Service Bulletin

SEB93-15

ELECTRICAL PUSH-PULL SWITCH REPLACEMENT

TITLE PUSH-PULL SWITCH REPLACEMENT - T41A

Figure 1. Push-Pull Switch Replacement (Sheet 4)

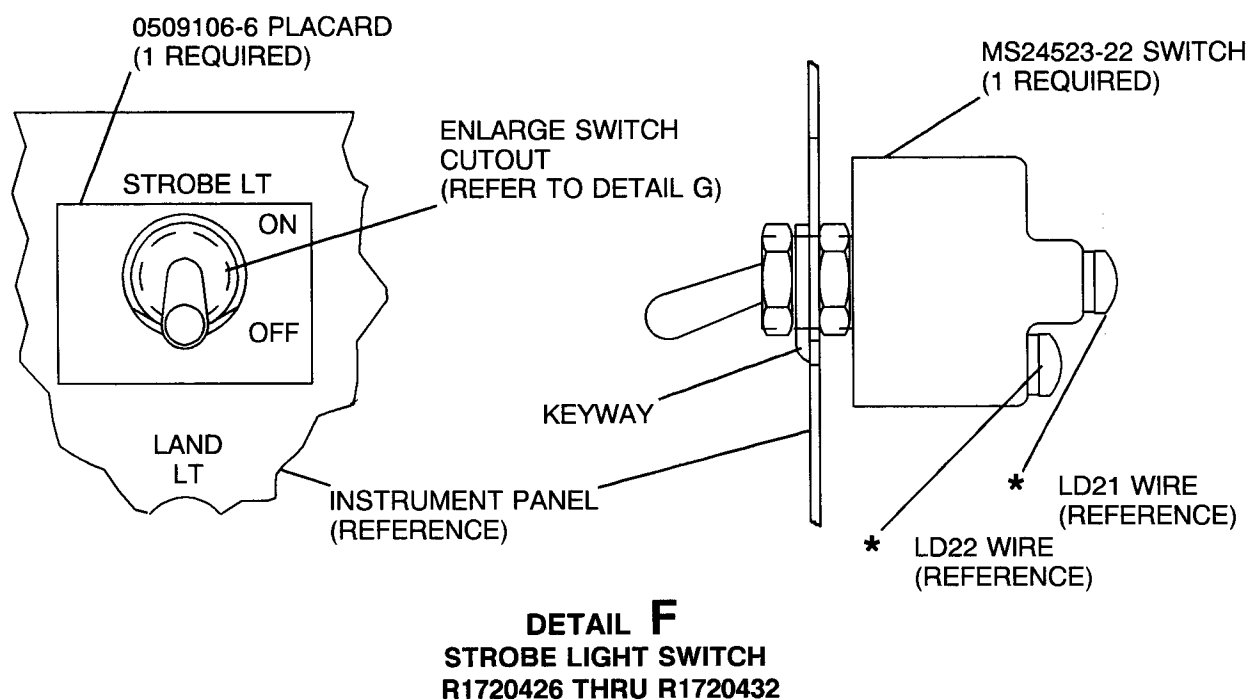
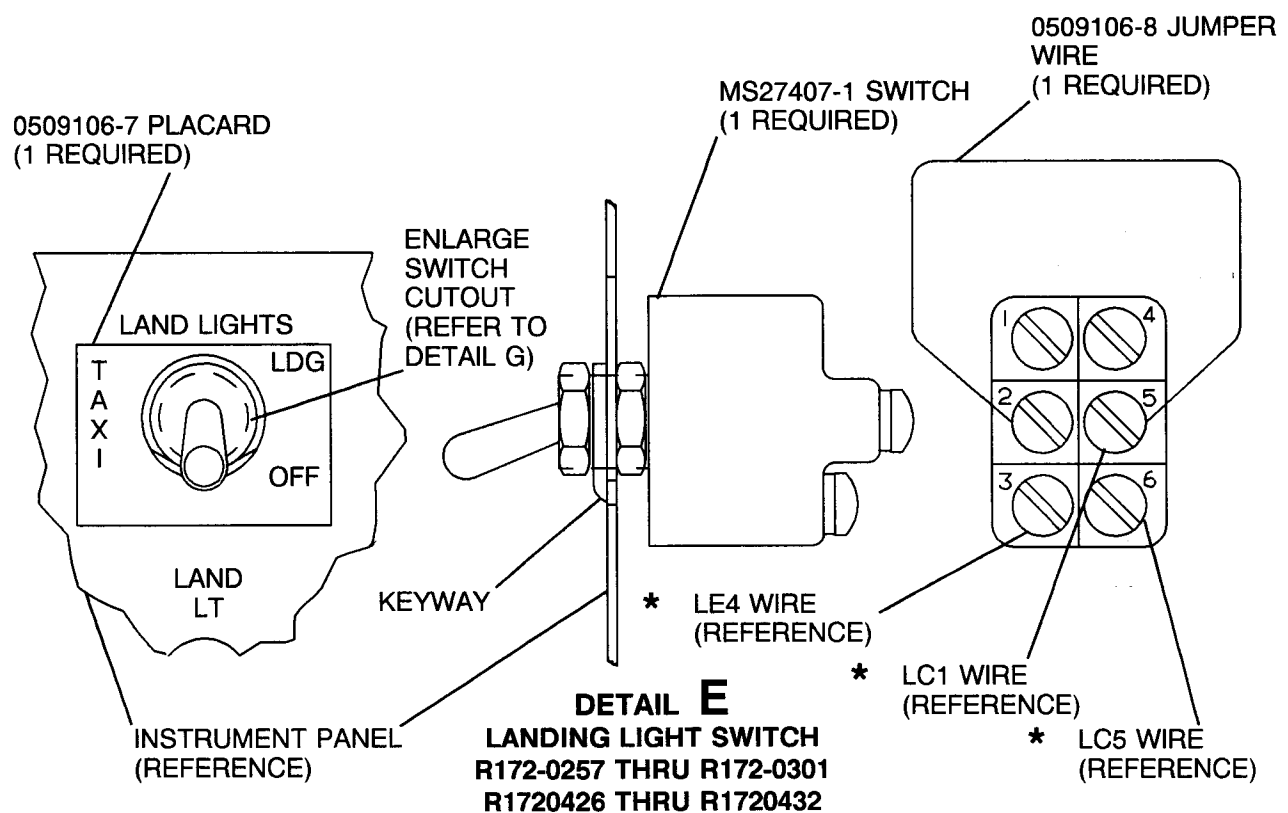
- D. (Refer to Figure 1, Detail F, Sheet 4) Gain access and remove existing Strobe light switch, if required, from instrument panel. Disconnect wiring and remove switch.

- B. (Refer to Figure 1, Detail E, Sheet 4) Gain access and remove existing landing light switch from instrument panel. Disconnect wiring and remove and discard switch.

- E. Refer to Figure 1, Detail E, Sheet 4) Install 0509106-7 placard on instrument panel as shown.
 - F. Connect the wires to the switch terminals and install 0509106-8 jumper wire on switch terminals as shown on the illustration.

DETAIL G
ENLARGED SWITCH CUTOUT IN INSTRUMENT PANEL

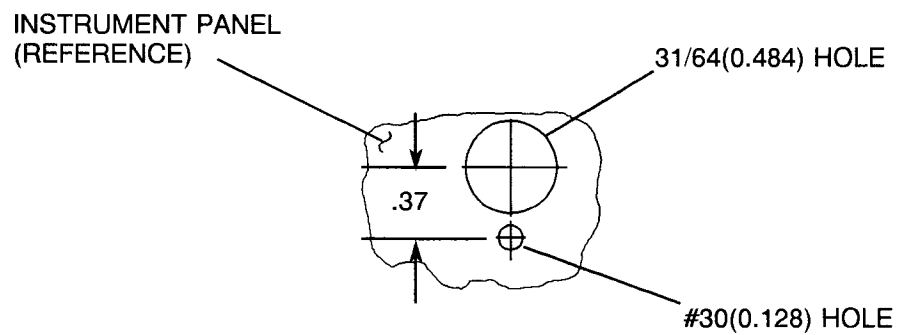
- C. Remove existing S1367-1-8 terminals from the affected wires as shown. Install the new S1367-1-6 terminals on the affected wires.
 - D. (Refer to Figure 1, Detail G, Sheet 5) Enlarge existing cutout in the instrument panel where the old switch was removed per the dimensions shown. Deburr and clean hole as required.

- F. (Refer to Figure 1, Detail G, Sheet 5) Enlarge existing cutout in the instrument panel where the old switch was removed per the dimensions shown. Deburr and clean hole as required.

- C. Remove existing S1367-1-8 terminals from the affected wires as shown. Install the new S1367-1-6 terminals on the affected wires.
 - D. (Refer to Figure 1, Detail G, Sheet 5) Enlarge existing cutout in the instrument panel where the old switch was removed per the dimensions shown. Deburr and clean hole as required.

Figure 1. Push-Pull Switch Replacement (Sheet 2)

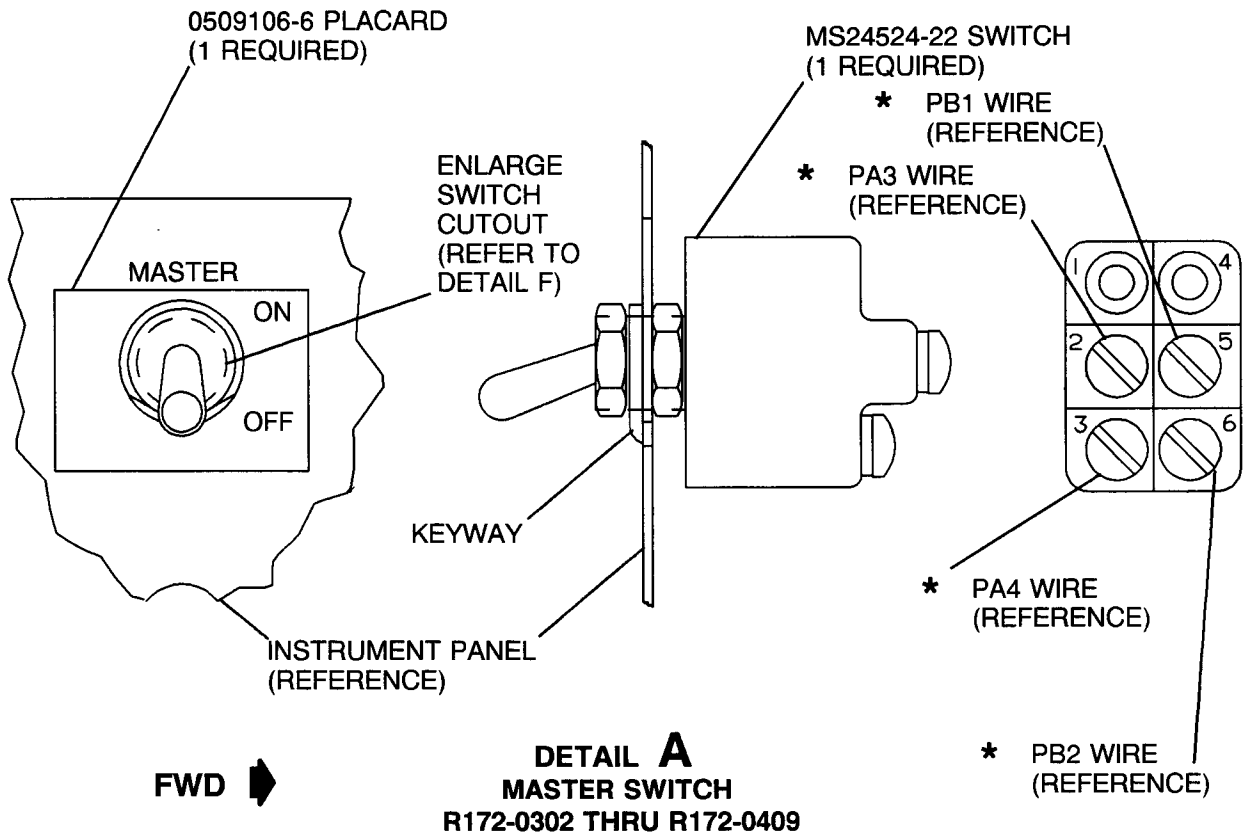
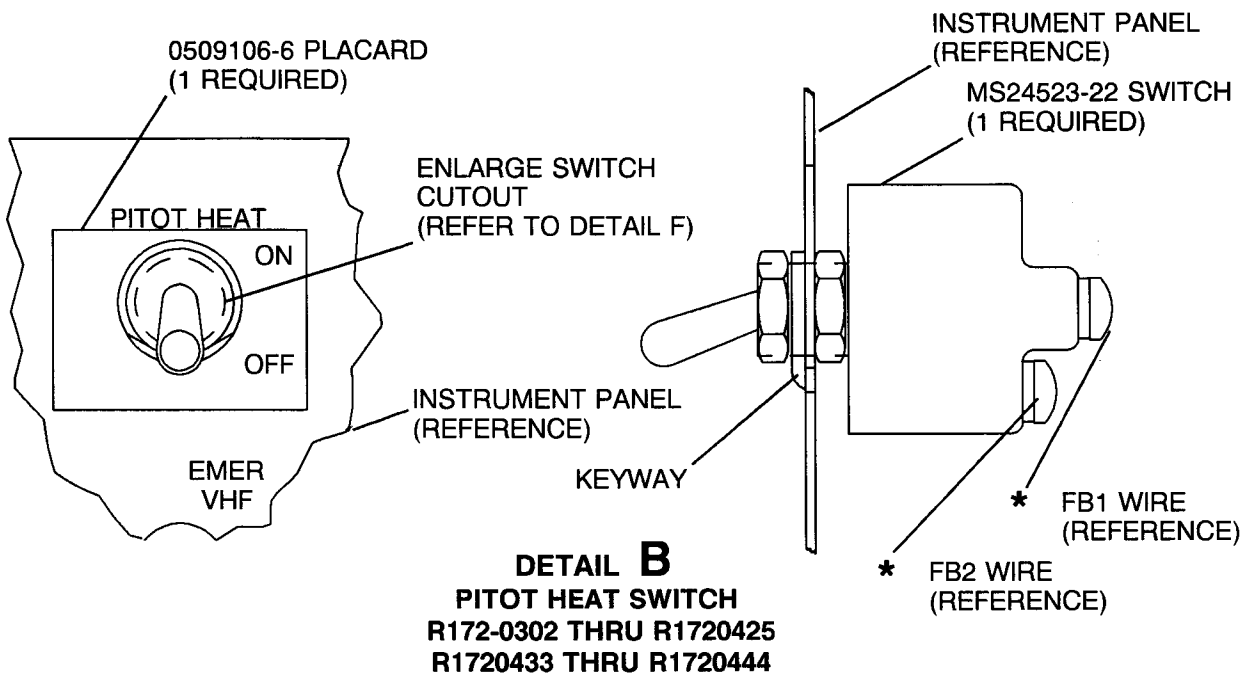
- B. (Refer to Figure 1, Detail A, Sheet 2) Gain access and remove existing master switch from instrument panel. Disconnect wiring and remove and discard switch.
- C. Remove existing S1367-1-8 terminals from the affected wires as shown. Install the new S1367-1-6 terminals on the affected wires.
- D. (Refer to Figure 1, Detail F, Sheet 4) Enlarge existing cutout in the instrument panel where the old switch was removed per the dimensions shown. Deburr and clean hole as required.
- E. (Refer to Figure 1, Detail A, Sheet 2) Install 0509106-6 placard on instrument panel as shown.
- F. Connect the wires to the switch terminals as shown on the illustration.
- G. Install new switch in instrument panel using hardware furnished with switch.
- H. Reconnect battery cable and check new switch for proper operation.

- B. (Refer to Figure 1, Detail B, Sheet 2) Gain access and remove existing pitot heat switch from instrument panel. Disconnect wiring and remove and discard switch.
- C. (Refer to Figure 1, Detail D, Sheet 3) Gain access and remove existing beacon light switch from instrument panel. Disconnect wiring and remove and discard switch.
- D. Remove existing S1367-1-8 terminals from the affected wires as shown. Install the new S1367-1-6 terminals on the affected wires.
- E. (Refer to Figure 1, Detail F, Sheet 4) Enlarge existing cutout in the instrument panel where the old switch was removed per the dimensions shown. Deburr and clean hole as required.

Figure 1. Push-Pull Switch Replacement (Sheet 3)

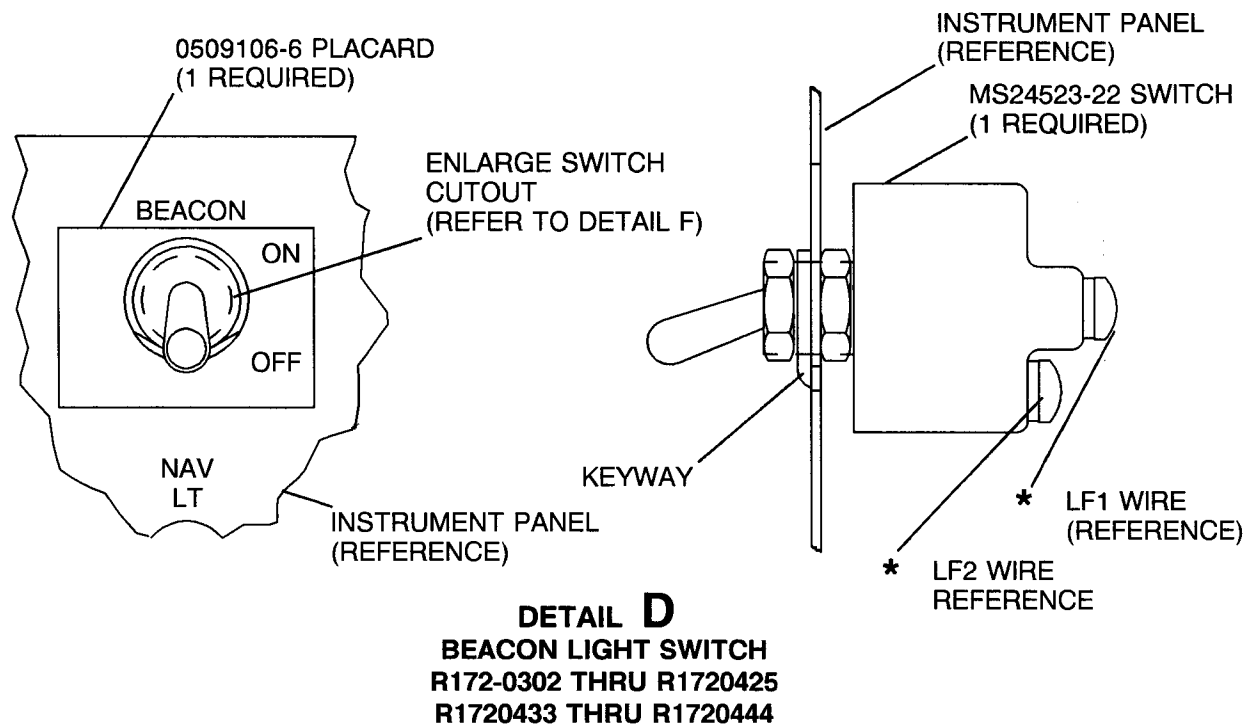
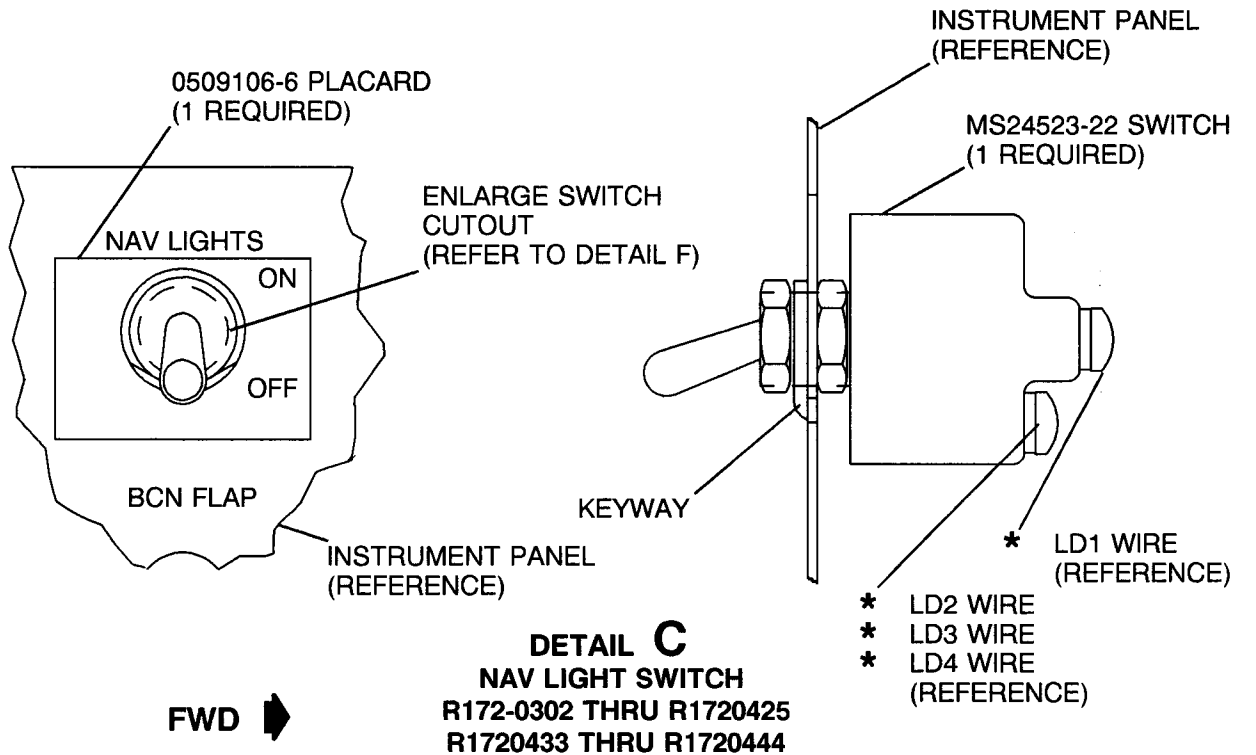
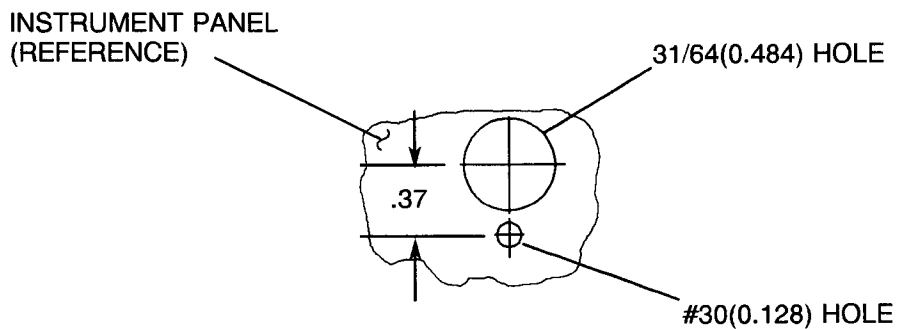
- B. (Refer to Figure 1, Detail C, Sheet 3) Gain access and remove existing nav light switch from instrument panel. Disconnect wiring and remove and discard switch.

- E. (Refer to Figure 1, Detail C, Sheet 3) Install 0509106-6 placard on instrument panel as shown.
 - F. Connect the wires to the switch terminals as shown on the illustration.

DETAIL F
ENLARGED SWITCH CUTOUT IN INSTRUMENT PANEL

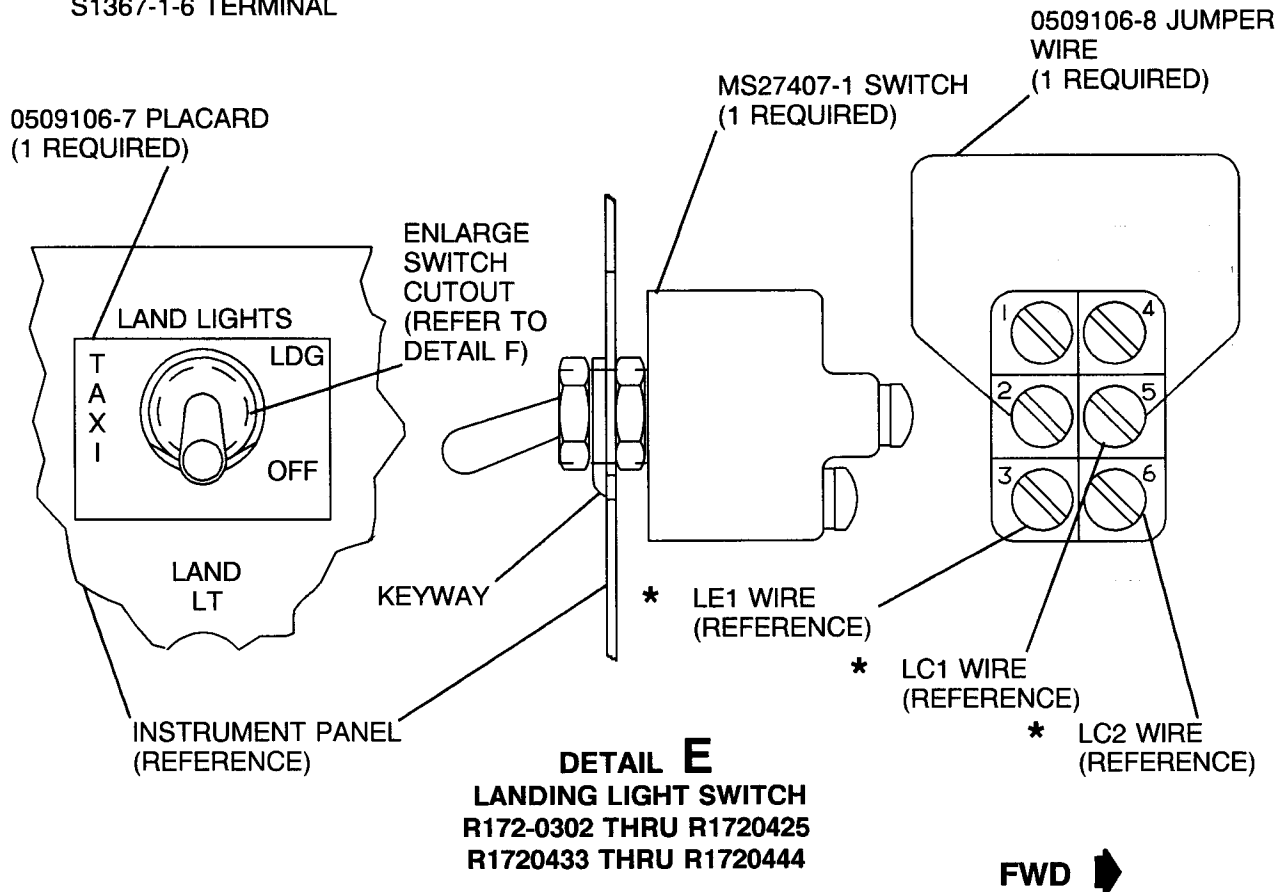
- C. Remove existing S1367-1-8 terminals from the affected wires as shown. Install the new S1367-1-6 terminals on the affected wires.
 - D. (Refer to Figure 1, Detail F, Sheet 4) Enlarge existing cutout in the instrument panel where the old switch was removed per the dimensions shown. Deburr and clean hole as required.

- B. (Refer to Figure 1, Detail E, Sheet 4) Gain access and remove existing landing light switch from instrument panel. Disconnect wiring and remove and discard switch.

- C. Remove existing S1367-1-8 terminals from the affected wires as shown. Install the new S1367-1-6 terminals on the affected wires as shown.
 - D. (Refer to Figure 1, Detail F, Sheet 4) Enlarge existing cutout in the instrument panel where the old switch was removed per the dimensions shown. Deburr and clean hole as required.

- E. Refer to Figure 1, Detail E, Sheet 4) Install 0509106-7 placard on instrument panel as shown.
 - F. Connect the wires to the switch terminals and install 0509106-8 jumper wire on switch terminals as shown on the illustration.
